STAFF RECOMMENDATION
1101 Sixth Avenue North/601 Madison Avenue
(Elliott School)
July 21, 2021

Application: Addition (Revisions to Previously Approved Plans)
District: Germantown Historic Preservation Zoning Overlay
Council District: 19
Map and Parcel Number: 08213038600
Applicant: Manuel Zeitlin
Project Lead: Melissa Baldock, melissa.baldock@nashville.gov

Description of Project: The applicant requests revisions to the rooftop additions previously approved under preservation permit #201626013. The revisions have already been constructed.

Figure 4 (left) is the roof plan approved in 2016 and Figure 5 (right) is the proposed roof plan.

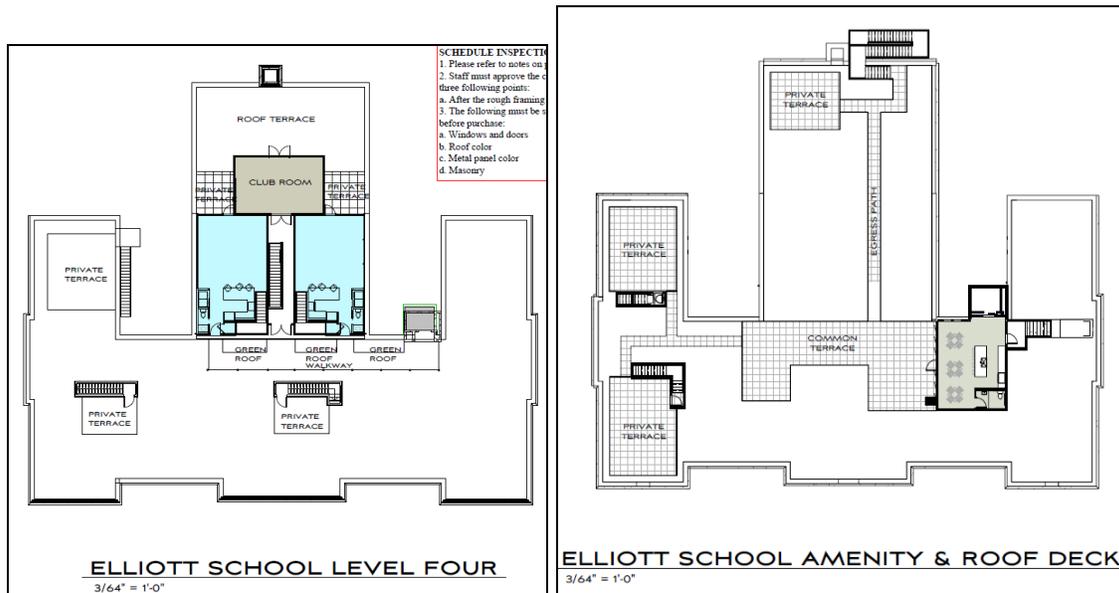
Both the previously approved plan and the revised plan include a main rooftop enclosed area with habitable space and several stair bulkhead towers. The previously approved roof plan shows that the habitable rooftop addition would be in the middle of the roof, but pushed to the rear of the building. It had a footprint of over two thousand, three hundred square feet (2,300 sq. ft.) (Figure 4). The revised plans show a much smaller habitable rooftop addition with a footprint of approximately five hundred and fifty square feet (550 sq. ft.) (Figure 5). However this revised plan shows the smaller habitable rooftop addition to be pushed up closer to both 6th Avenue North and Madison Street. It is drawn to be approximately twenty-five feet (25') back from the Madison Street façade and seventeen feet (17') from the 6th Avenue North façade.

Figure 11. The view of the Madison Street bulkheads from a vacant lot at Madison Street and 5th Avenue North. Once the townhouses are built on this lot, this view will not be possible.

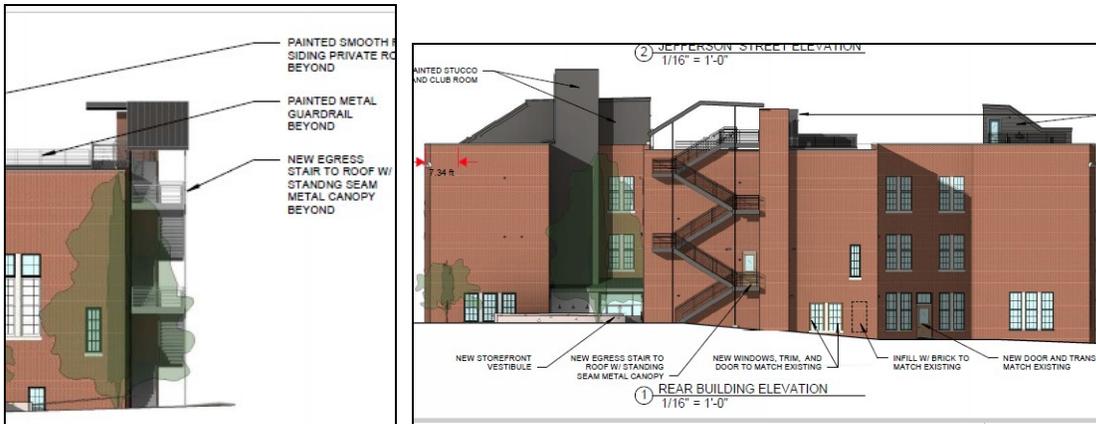
The applicant also proposes a stair bulkheads facing the Madison Street façade which are different than what was previously approved (Figures 11 & 12). Part of the stair bulkhead on the right side of the Madison Street façade will be approximately fifteen feet, ten inches (15'10") tall at its tallest point. However, this tallest portion is just about eight feet (8') wide and is setback thirty feet (30') from the parapet. Staff therefore finds it to be appropriate.

The most visible part of the rooftop addition on the Madison Street façade is the slanted stairway bulkhead. This stairway is only set back approximately seven feet (7') from the parapet and it slants up to have a resulting height of approximately eleven feet (11'). This portion of the addition is currently white in color, which makes it stand out more than the areas that are painted a dark grey/black color. Staff finds that if the slanted stair bulkhead and the narrower bulkhead next to it are painted a dark color, they would read as utilitarian rooftop intrusions that do not detrimentally affect the historic character of the historic school structure. Also, currently, these elements are highly visible at 5th Avenue and Madison Street because there is a vacant lot. MHZC has approved townhouses for these lots as part of this larger Elliott School project. Once these townhouses are constructed, the view of this slanted stair bulkhead will not disappear entirely, but it will be diminished substantially. Staff therefore finds that if all rooftop intrusions are painted a dark grey or black color, they are appropriate for the historic school structure.

The materials of the rooftop intrusions are similar to what was approved in the 2016 permit. They are a mixture of stucco and metal panels. With the condition that all of the rooftop intrusions be a dark grey or black color, staff finds that they meet the design guidelines.
